REBECCA HILLS SUBDIVISION, **RESUBDIVISION OF LOT 1**

APPLICATION NUMBER 6 DATE October 19, 2006

DETAIL SITE PLAN

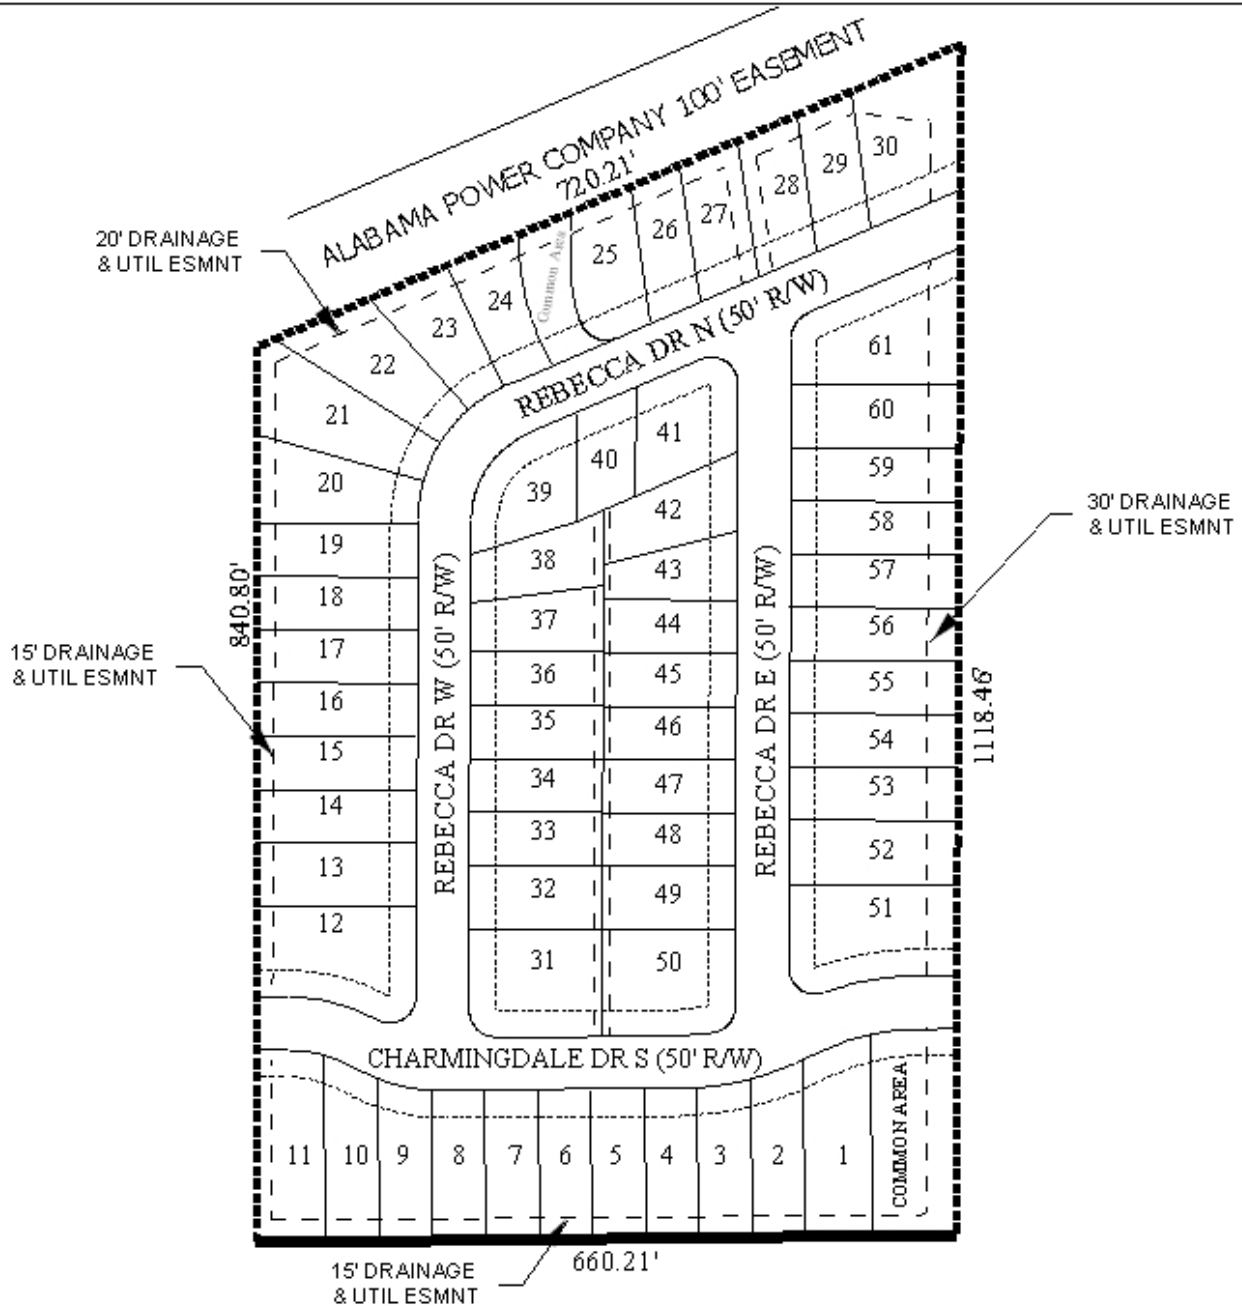
The site fronts onto street stubs for both Charmingdale Drive South and Thorman Drive, both are minor streets. Each street lacks curb-and-gutter, thus the 50-foot right-of-way is less than the minimum required 60-foot width. It should pointed out that the proposed street that will be part of the subdivision appears to currently exist, however, it appears to lack curb-and-gutter, thus the proposed 50-foot right-of-way is not adequate due to the lack of curb-and-gutter. The subdivision should be redesigned to accommodate the required 60-foot wide right-of-way, or the applicant should indicate that the site will have a subsurface stormwater drainage system.

A number of lots fall below the required 7,200 square foot minimum. The applicant states: *"The desire is to build retro cottage style homes that are small and affordable. Some of the proposed lots are smaller than the 7,200 minimum. However, when the total area of 14.85 acres is considered with 61 lots (including common areas), ach lot will average 8,558 square feet. We feel that the average square footage will be adequate."* The applicant goes on to state that *"homes will be in close proximity to one another to resemble the neighborhoods in the older sections of Mobile."* The smallest lot size appears to be approximately 6,250 square feet.

The applicant's proposal does invoke Section VIII.C. of the Subdivision Regulations, allowing innovative design. While the lot sizes may be less than recommended within the Subdivision Regulations, they do reflect "Smart Growth" sensibilities, and none of the proposed lots appear to be smaller than, for example, the proposed Transitional-Business zoning category recently passed by the Planning Commission. As this site is in the County, which has no zoning, a waiver of the minimum lot size requirement of Section V.D.2. of the Subdivision Regulations may be appropriate.

Common areas are proposed for the subdivision. All common areas (including detention basins) should be labeled, and a note should be placed on the final plat, if approved, stating that maintenance of any common areas is the responsibility of the subdivision's property owners.

While the site is in the County, the applicant's engineer will be required to certify that the stormwater detention, drainage facilities, and release rate comply with the City of Mobile stormwater and flood control ordinances, prior to the signing and recording of the final plat, if approved. The plat should also be revised to depict contour data, as required by the Subdivision Regulations.

This site is located in Mobile County, thus a note should be placed on the final plat stating that any lots which are developed commercially and adjoin residentially developed property must provide a buffer, in compliance with Section V.A.7. of the Subdivision Regulations.

Based upon the preceding, the application is recommended for Tentative Approval under Section VIII.C. of the Subdivision Regulations (Innovative Design), subject to the following conditions: 1) provision of a certification letter from a licensed engineer to the Planning Section of Urban Development, certifying that the stormwater detention, drainage facilities, and release rate comply with the City of Mobile stormwater and flood control ordinances, prior to the signing and recording of the final plat; 2) depiction on the final plat of the contour information required by the Subdivision Regulations; 3) labeling of all common areas, and placement of a note on the plat stating that maintenance of any common areas is the responsibility of the subdivision's property owners; 4) revision of the plat to label each lot in square feet, or provision of a table on the plat depicting the same information; and 5) placement of a note on the plat stating that any lots which are developed commercially and adjoin residentially developed property must provide a buffer, in compliance with Section V.A.7. of the Subdivision Regulations.
